Final Plat Grand Meadow Subdivision

August 19, 2020

REF.: Grand Meadow Subdivision Construction Plans

Project Number: 20-00022-S-SUBD

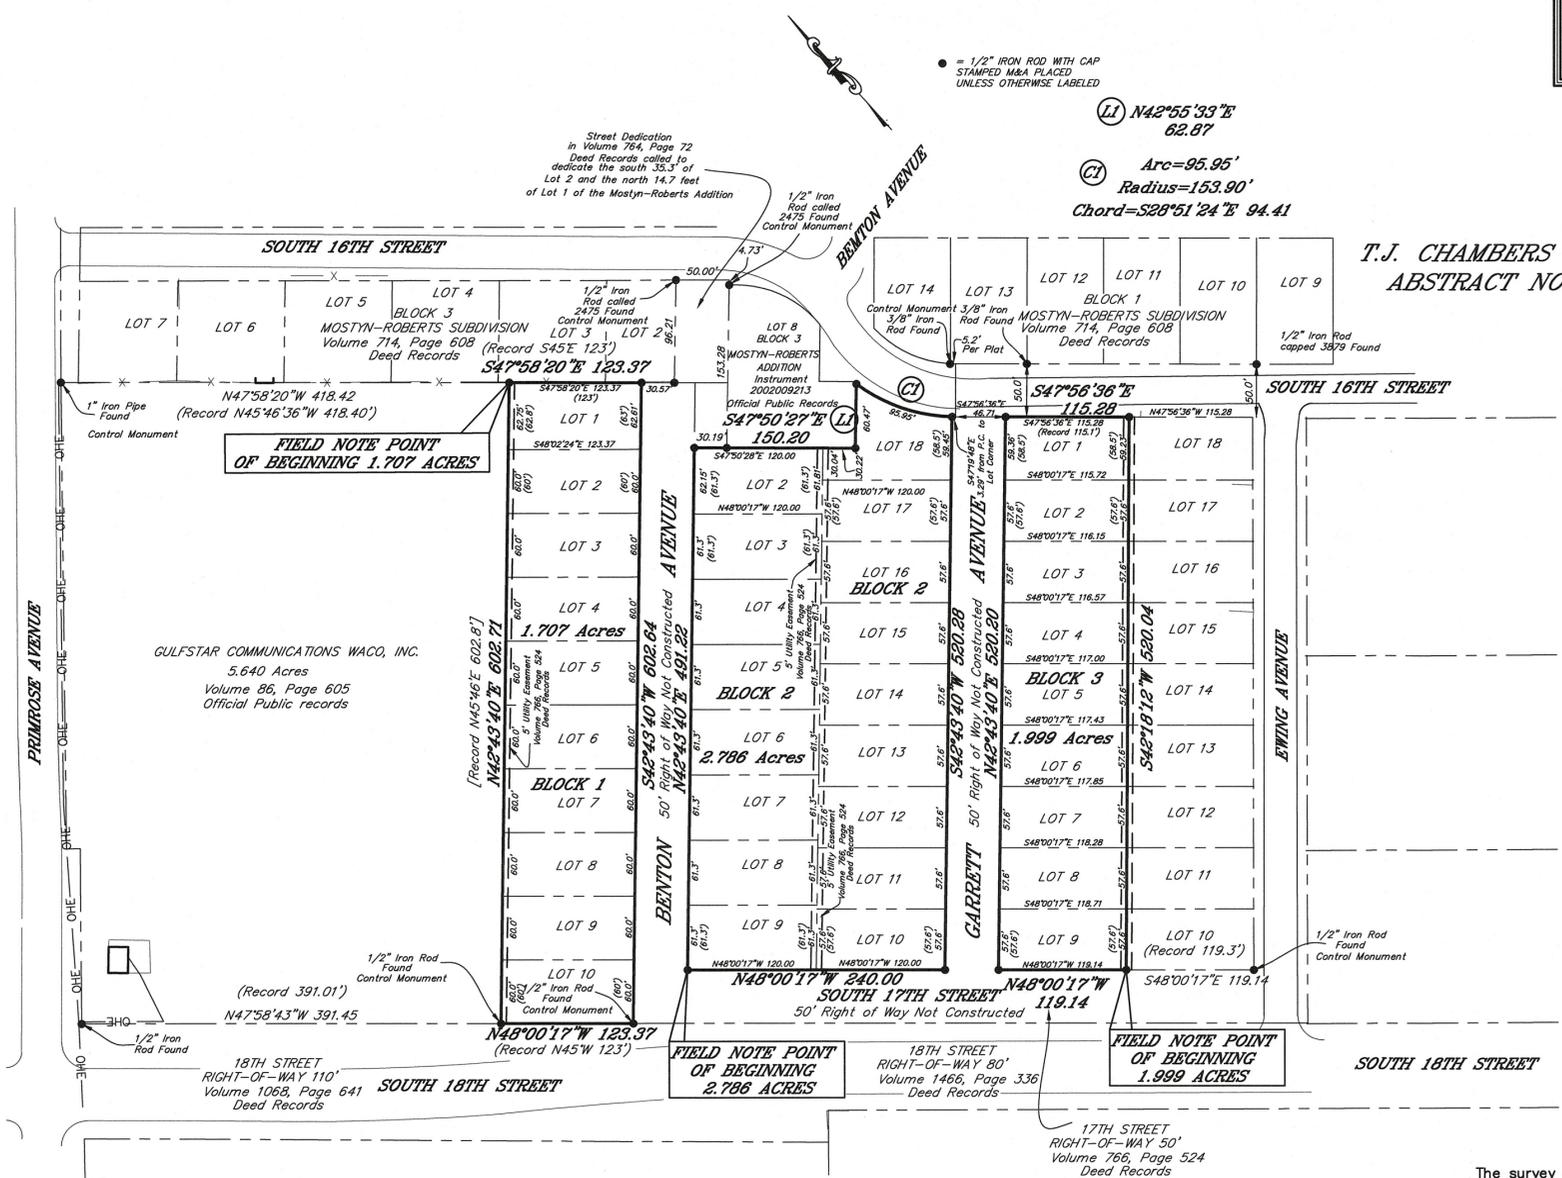
1. Benton Avenue shall intersect with S 18th Street.
2. Garrett Avenue shall dead-end as a cul-de-sac prior to S 18th Street.
3. The connecting street shown parallel to S 18th Street shall be removed from the design and not constructed.

6. Sidewalk is required along S 18th Street, Benton Avenue, Garrett Avenue, and S 16th Street. (Ordinance App. B Section 5.207)
7. Sidewalk connection between the Garrett Avenue cul-de-sac and S 18th Street sidewalks should be included.
